Installation Instructions: New A8 Cassette Interface BOARD Part Number: SP9403701

Due to parts that have become obsolete, the A8 BOARD has been redesigned for use in the following equipment:

CASSETTE INTERFACE BOARD A8

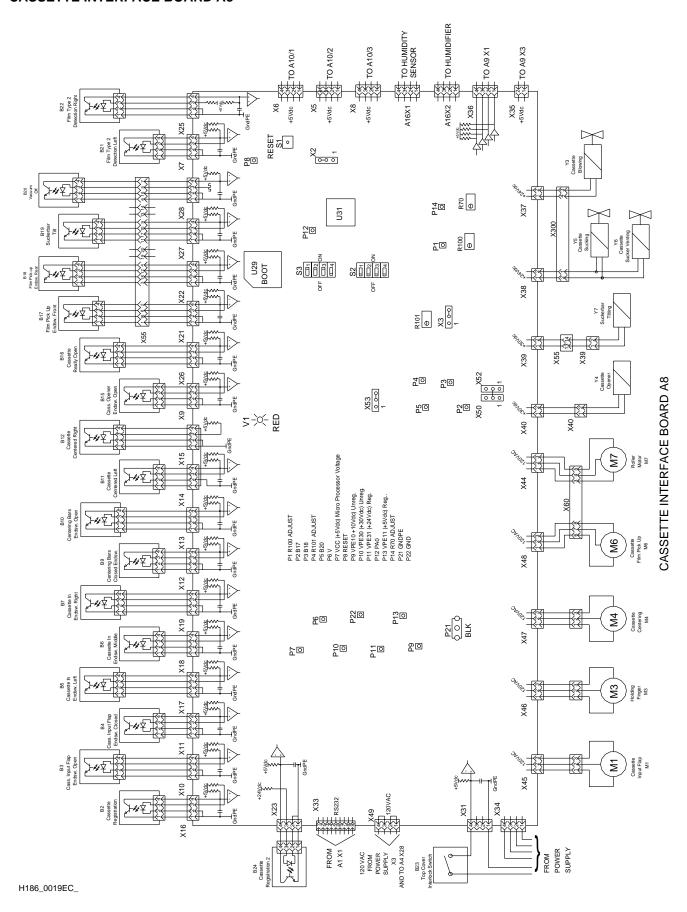
NOTE: When installing new A8 BOARD to a XML300/300 PLUS, MINILOADER 2000/2000P new test points and circuit board diagram must be used for service.

P1 (green) R100 Adj sensor input B22/CT2L P2 (green) sensor input B17/CPUEF P3 (green) sensor input B18/CPUER P4 (green) R101 Adj sensor input B22/CT2R sensor input B20/CPUVO P5 (green) P6 (red) VμP P7 (red) VCC (+5 Vdc) micro process voltage P8 (green) _RESET P9 (red) Vpe10 (+10 Vdc) Unreg P10 (red) Vpe30 (+30 Vdc) Unreg Vpe31 (+24 Vdc) Reg P11 (red) P12 (green) FPGA PA0 P13 (red) Vpe11 (+5 Vdc) Reg **R70 ADUST** P14 (green) P21 (black square) GNDpe peripheral ground P22 (black) GNDuP micro controller voltage ground
